## Stage 03: Modification Report

# GSR014: Review of Requirement of Onshore Connection Facilities for Offshore Wind Farm Connections

This Modification Report seeks to modify NETS SQSS Section 7.13.1.1: Onshore Connection Facilities: AC Circuits.

Figure 1. Schematic diagram of the offshore transmission system designs considered.

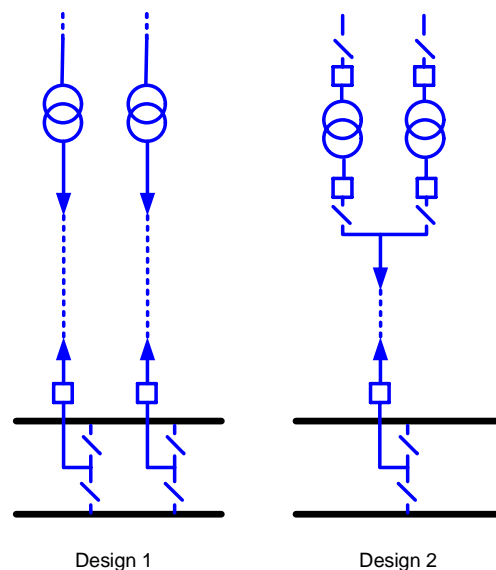
- (i) Several respondents stated that they would prefer that a standard requirement for 2 switch-bays was not included in the NETS SQSS. They would prefer a cost benefit assessment be carried out on each design.
- (ii) Several respondents were concerned as to whether the cost benefit analysis had been sufficiently broad. Additional cases were identified including generation entry capacities below 250MW, longer cable lengths and the connection to 275kV substations.
- (iii) One respondent was concerned as to whether other equipment such as reactive compensation should be factored into the assessment.

- (v) One respondent was concerned that the capital costs of a two switch-bay connection could be much higher than assumed in the analysis.
- (vi) One respondent suggested a potentially less expensive design option based on disconnectors.

No, we believe that a more detailed assessment is required. The methodology used for the assessment seems sound (although we are not in the position to comment on each single calculation that has been performed): however, only a few cases are assessed here and it is our view that it is not possible to generalise the approach and amend the SQSS based on the scenarios considered in the group report. In particular, we have the following concerns:

1. The SQSS section 7.13.1.1 refers to wind farms with GEP capacity of 120MW or above. However, the study compares only wind farms with capacity at GEP of 250MW or above. The conclusion that a configuration with a double bay is the best solution for wind farms of sizes between 120 and 250MW cannot be drawn based upon the presented calculations, also given the fact that the presented results show a decrease in benefits of having two bays when the wind farm decreases its capacity.

2. Only connection to 400kV TIP is considered in this work: would the results be similar for connection to 275kV, given the difference in costs for cables, circuit breakers and transformers?

3. Have NGET's costs to provide connection for one or two bays within their GIS or AIS equipment been included in the assessment? What we refer to here is the skeletal bay that is needed to connect the wind farm bay to NGET's AIS or GIS substation (one per connection). We believe that this should be included as it would have an impact on the CBA results.

4. 400kV cable lengths between 50 and 250m are considered in this work: however, projects have connection with underground cables up to 600-700m. This would have an impact on both cable costs (which would increase) and cable availability (which is based on cable lengths). It is not possible to generalise the results in the way that has been presented in the consultation.

5. Offshore wind farms are sometimes required to install 275kV or 400kV filters and associated equipment at the TIP to mitigate harmonic issues. The need for this equipment may require the inclusion of additional banking or t-off connection to achieve a compliant solution and this could potentially reduce or completely eliminate the economic advantage of the proposed configuration via two bays. We believe this should be considered in the assessment of this consultation.

4.6 The workgroup assessment has demonstrated that where there are 2 transformers, it is economic to have 2 switch-bays except in exceptional circumstances. Making 2 switch-bays as the standard connection is clearer than the current position and does not preclude other connections if these are shown to be cost-beneficial. (However, if it was decided to bank 2 transformers onto a single switch-bay, this would require derogation.)

4.8 The working-group has carried out additional analysis to investigate the effects of a significantly longer cable length of 700m.

4.9 It was found that significantly longer cable lengths do impact upon the overall results of the volume of wind energy curtailed and its associated costs. This can be seen in Table 1 below. More complete and detailed results tables can be found in Annex 3 of this Modification Report. The results do not affect the conclusions of the working-group and a two bay configuration remains the most economic and efficient solution to connect an offshore wind farm.

4.11 The capital costs for 275kV substations will be similar to or below the costs of 400kV substations. Therefore the main conclusions from the cost benefit analysis will apply to 275kV onshore connection facilities also.

4.13 Further concerns were raised with respect to the working-groups analysis not taking into consideration the additional equipment that could be installed within a substation bay (i.e. filters, reactors...etc...). This equipment would increase the capital cost to a similar extent for the one or two switch-bay options and will also not materially affect the availability of the wind farm or change the amount of wind farm energy curtailment. Therefore, inclusion of this additional equipment will not affect the final conclusions of the cost benefit analysis.

4.18 If the capital costs of a two switch-bay connection were particularly high compared to a single switch-bay connection, due to the need for major extension of an existing substation for example, this could be demonstrated through a cost benefit assessment and a design variation or derogation could be sought.

4.19 The workgroup considered disconnector based solutions but did not pursue these as they would lead to greater curtailment of generation capacity. For GIS substations, the cost differential between disconnector only and circuit breaker based solutions is also likely to be small.
